Re: 49 CFR Part 573 Defect Report

**Generic Name of the item:** Frame Rail Mounting System

**Make:** IFS **Model:** Electric APU BA600

The following is a picture of a Venture frame backer C-channel that showed deformity at the lower bolted area and subsequent bolt loosening.

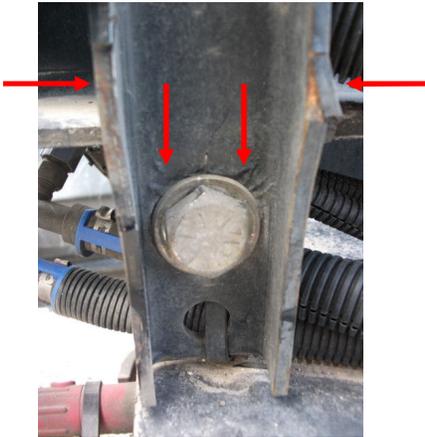
Incorrectly torqued bolts may result from inadequate strength of the backer C-channel. Deformity along with a loss of torque tightness has been witnessed in some installations. It is believed that a bending moment is created which fatigues the channel. The defect condition is the result of the existing backer C-channel design and the variable tightening torque used during APU vehicle installation.

Figure 1 - Area to review

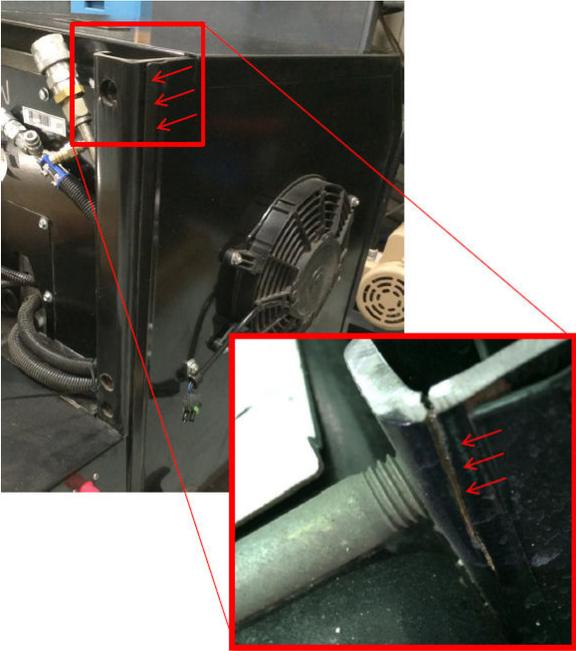
As indicated, an upgrade kit (as reviewed and approved by NHTSA) will be sent to all affected IFS dealers. The APU frame rail upgrade kit consists of two gusset plates, two backer brackets, mounting hardware and instructions. The gusset plates are to be welded to the top of the APU frame C-channel to prevent cracks from propagating along the channel radius. The backer brackets are installed on the back side of the vehicle frame rail by means of four bolts which attach directly to the APU frame. The upgrade will provide additional structural support alleviating the stresses on the APU that may be associated with backer bracket deformity and/or broken bolts. A decision tree such as found in attached Appendix One will help to guide the field inspection and corrections as required.
